From: David McCoy <dave@radfreenm.org>
Sent: Friday, November 09, 2012 2:29 PM
To: Kieling, John, NMENV; Martin, David, NMENV; Joni Arends; Robert H Gilkeson, registered geologist; Amigos Bravos/Michael Jensen (mjensen@amigosbravos.org); Brian Shields/Amigos Bravos (bshields@amigosbravos.org); CARD; CCNS/Joni Arends; CCNS/Sadaf Cameron; Meiklejohn, Doug; Jay Coghlan; John Witham/NukeWatch (john@nukewatch.org); Nuclear Watch/Scott Kovac; Sylvia Ledesma (lzkalli@comcast.net); Penny McMullen; Sheri Kotowski (serit@cybermesa.com); sricdon@earthlink.net (sricdon@earthlink.net)
Subject: Request for extension of comment period and to hold a public hearing for the SNL MWL LTMMP
Attachments: LTMMPFINALCOMMENT11-03-12.2d.doc

We, the undersigned, respectfully request that the New Mexico Environment Department (NMED) withdraw the issuance of the March 23, 2012 proposed Long-Term Monitoring and Maintenance Plan (LTMMP) for the Mixed Waste Landfill (MWL) at Sandia National Laboratories (SNL), submitted by SNL. We find that the sequence of review of the LTMMP is out of order with the requirement for SNL to submit the 5-year review of the MWL by May 26, 2010. The undersigned request an extension

Figure 2. Location of the new detection monitoring wells MWL-MW7, -MW8 and -MW9 along the western boundary of the Sandia MWL Dump and new background monitoring well MWL-BW2 200 feet east of the MWL Dump. The figure also shows

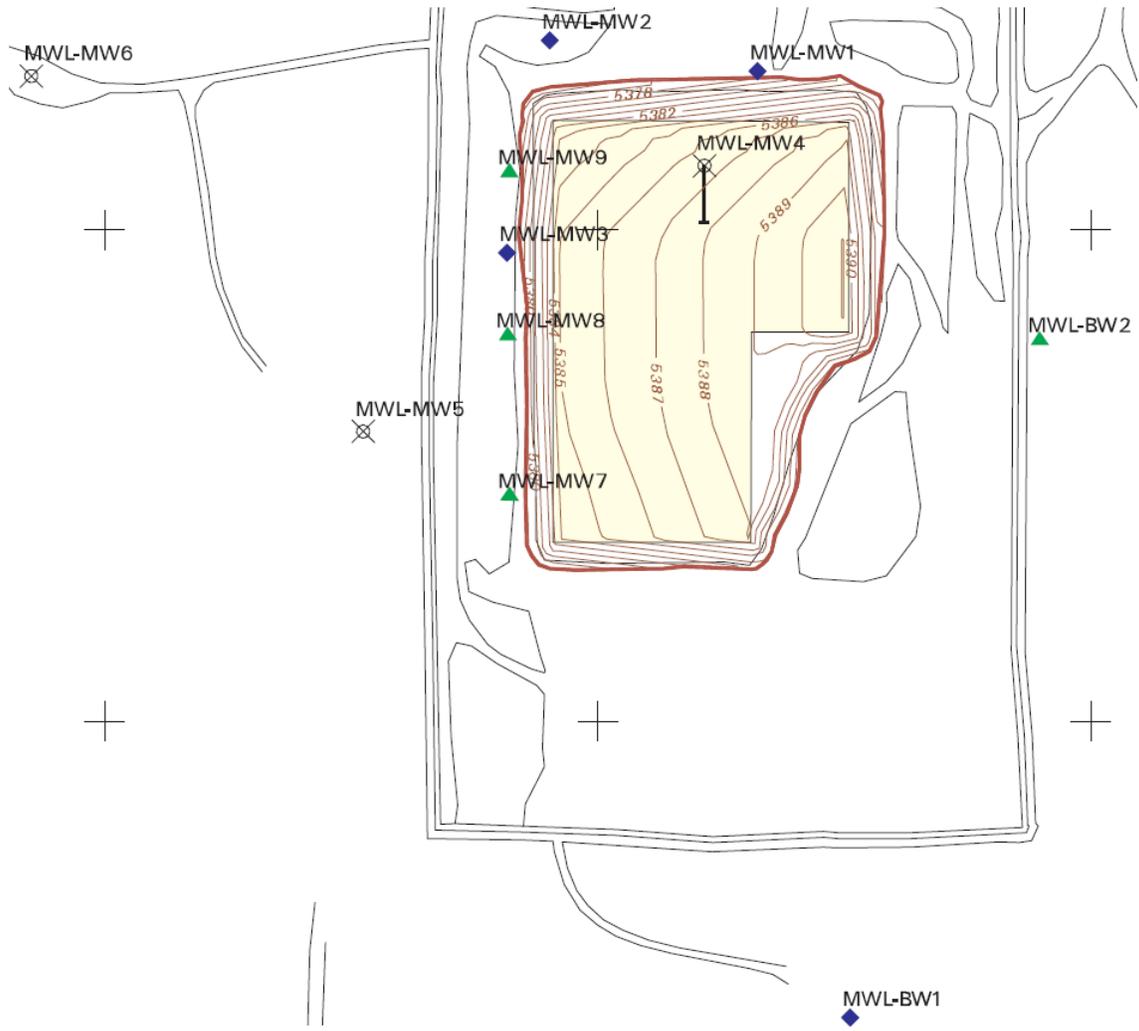
5. The four monitoring wells in the proposed LTMMP monitoring network are displayed on Figure 2 and include the three contaminant detection monitoring wells MWL-MW7, -MW8 and -MW9 located along the western side of the SNL MWL dump and the background monitoring well MWL-BW2 located 200 ft east of the dump. The proposed network is defective because monitoring wells MWL-MW7, -MW8 and -MW9 have water levels in October 2011 that are near to or less than 4 ft for sampling and do not provide reliable and representative groundwater samples as required by RCRA. The water levels are too low according to page 25 in the DOE/Sandia report by Goering et al. (2002) as follows:

The ongoing decline of water levels at 0.5 ft/yr means that the two monitoring wells MWL-MW8 and -MW9 are not able to provide reliable and representative groundwater samples. Further, well MWL-MW7 will not provide reliable and representative groundwater samples within the next year. The NMED March 2004 Compliance Order on Consent (Consent Order) on page 63 requires replacement of the three new defective monitoring wells as follows:

6. In addition, the proposed LTMMP monitoring network is defective because groundwater monitoring wells MWL-MW7, -MW8 and -MW9 have anomalously deep water levels by ~20 ft that do not represent the elevation of the water table below the MWL dump. The deep water levels are because of the strong downward hydraulic gradient in the fine-grained sediments and the 30-ft long screens in the three new wells. The NMED March 2004 Consent Order on page 194 requires

The anomalous low water levels measured in the three new wells MWL-MW7, -MW8 and -MW9 are evidence the wells do not provide the required knowledge of the elevation of the water table below the SNL MWL dump. As stated above in Topic 5, the NMED Consent Order requires replacement of monitoring wells that are not usable for the intended purpose.
